## REMARKS/ARGUMENTS

Appl. No. 10/072,707  
Amd. Dated November 21, 2005  
Reply to Office Action of September 21, 2005

**Amendments to the Drawings:**

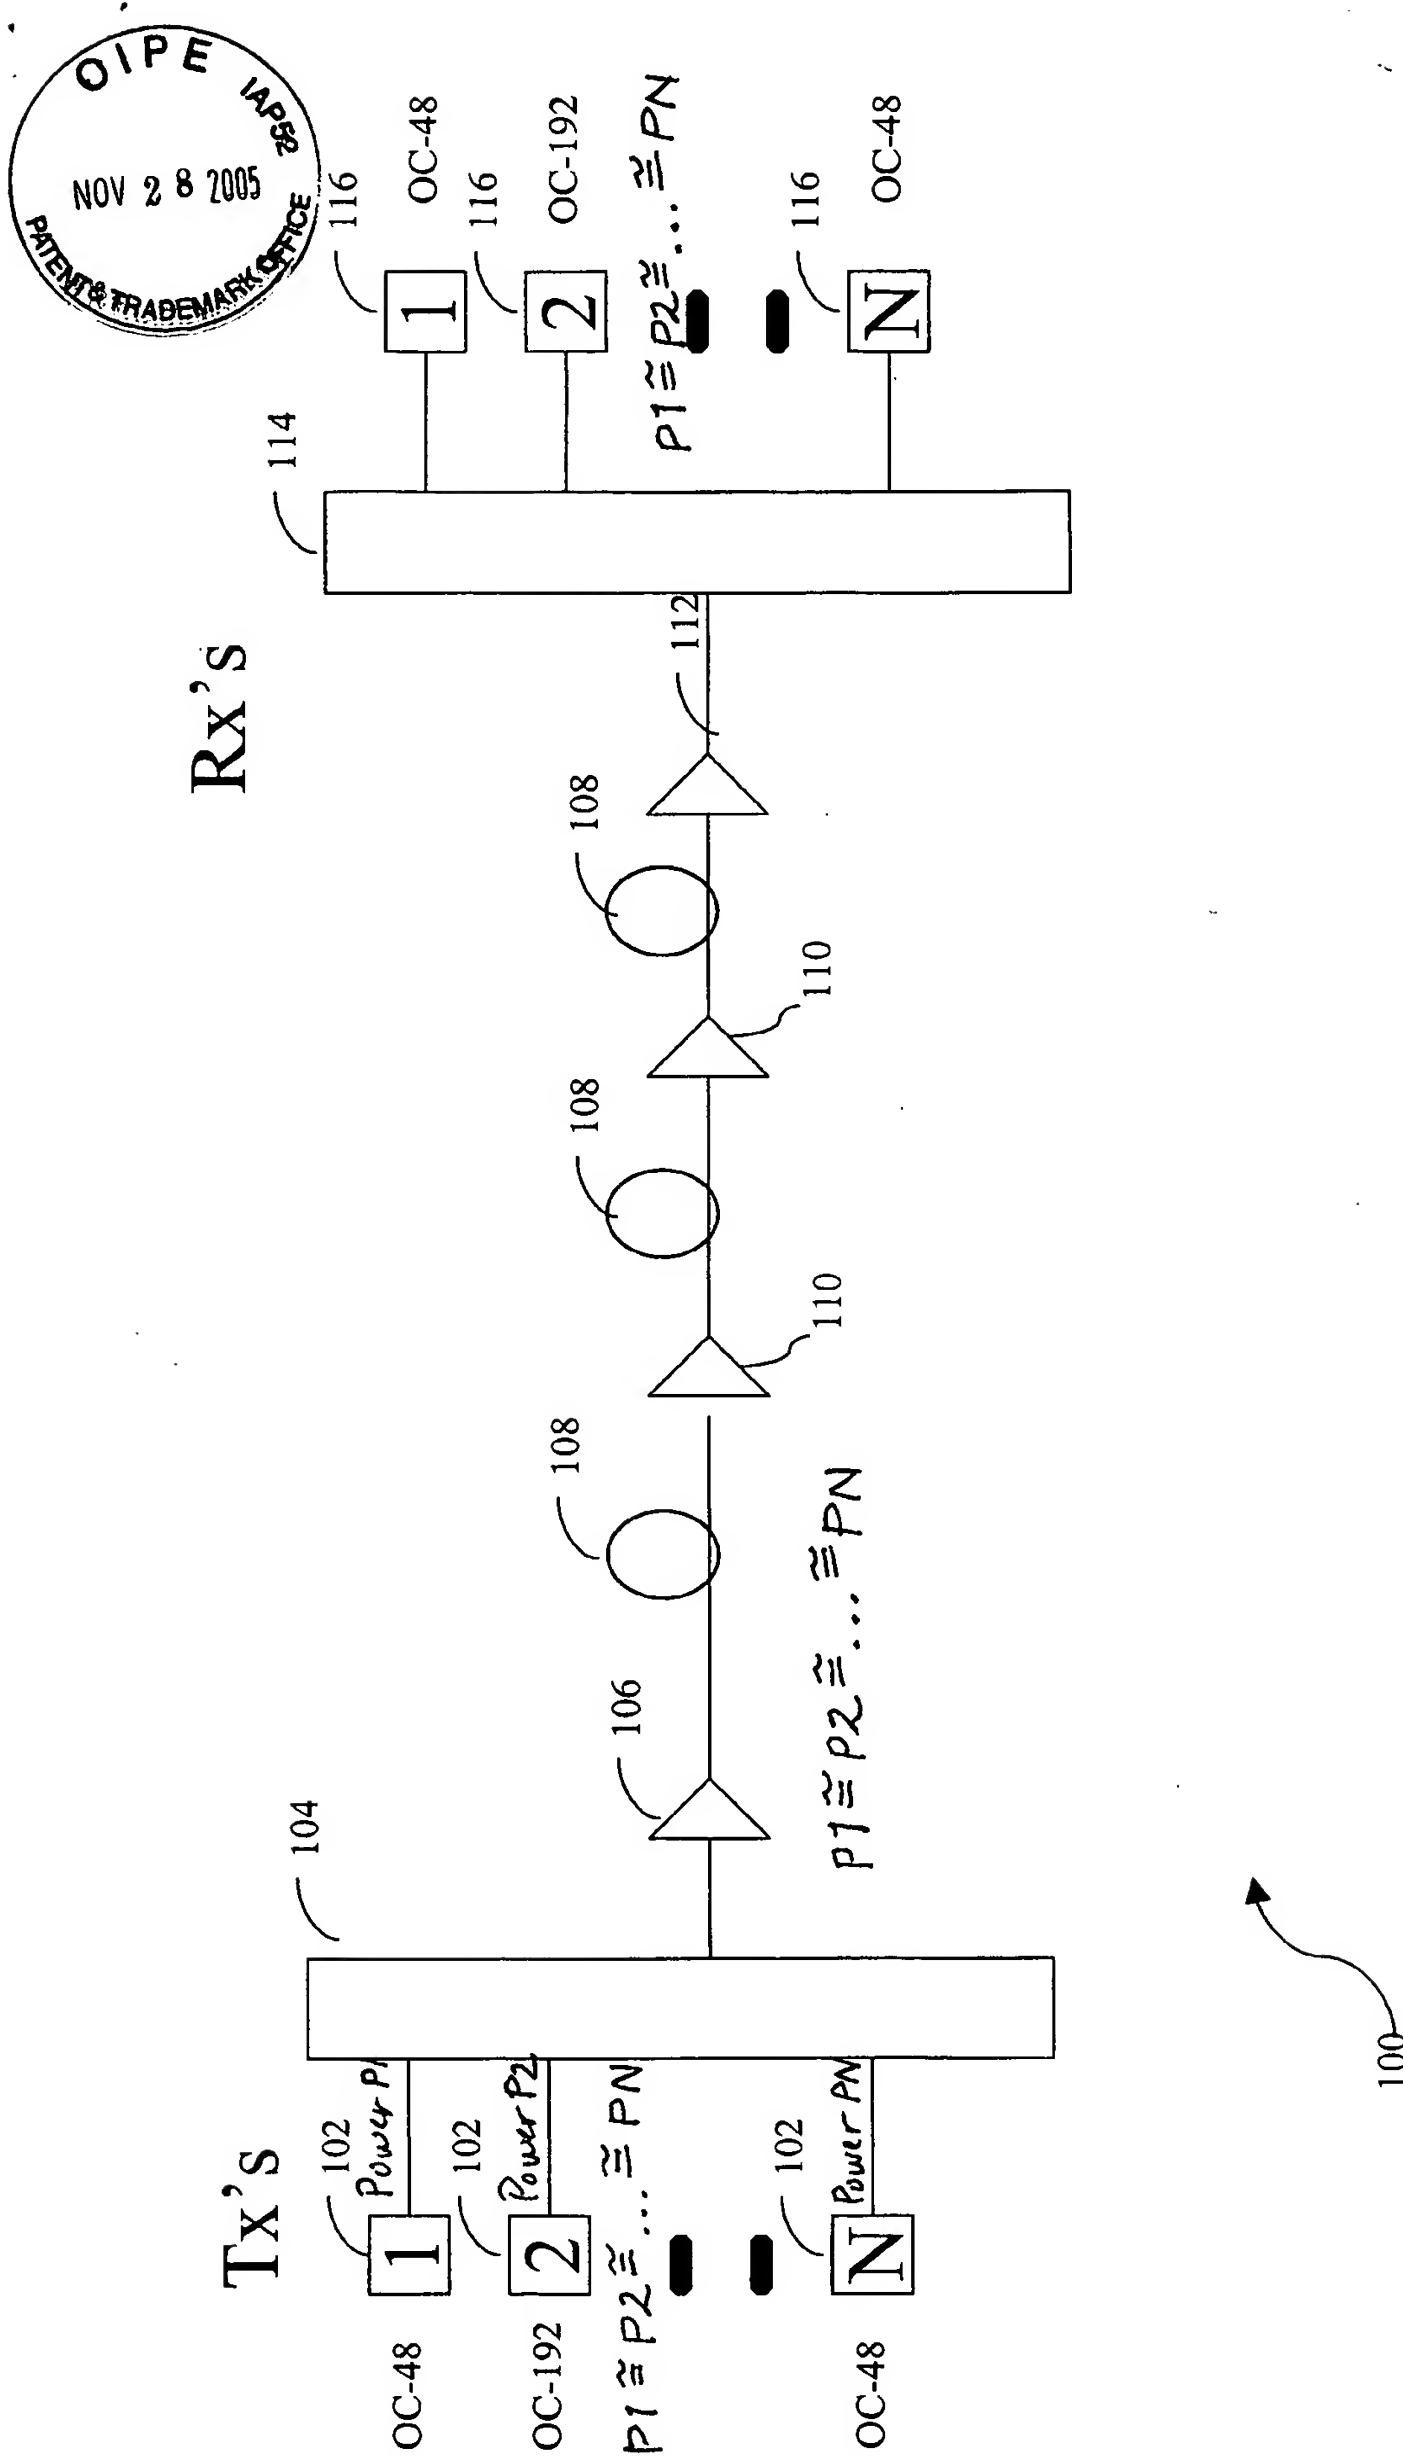
In response to the Examiner's continued objections to the drawings, a new drawing of Fig. 1 is submitted. The applicants note that support for these changes are found in at least originally submitted claims 7 and 21. With respect to the objection to previously submitted drawing for Fig. 4A, the applicants are uncertain as to what the Examiner's objections are and respectfully request that he withdraw his objections.

The attached sheet of drawings replaces previously submitted sheet including Fig. 1. The replacement drawing includes changes: to Fig. 1 on the left side of the drawing to indicate the general equality for the modulated optical signals when multiplexed together and for the modulated optical signals after amplification.
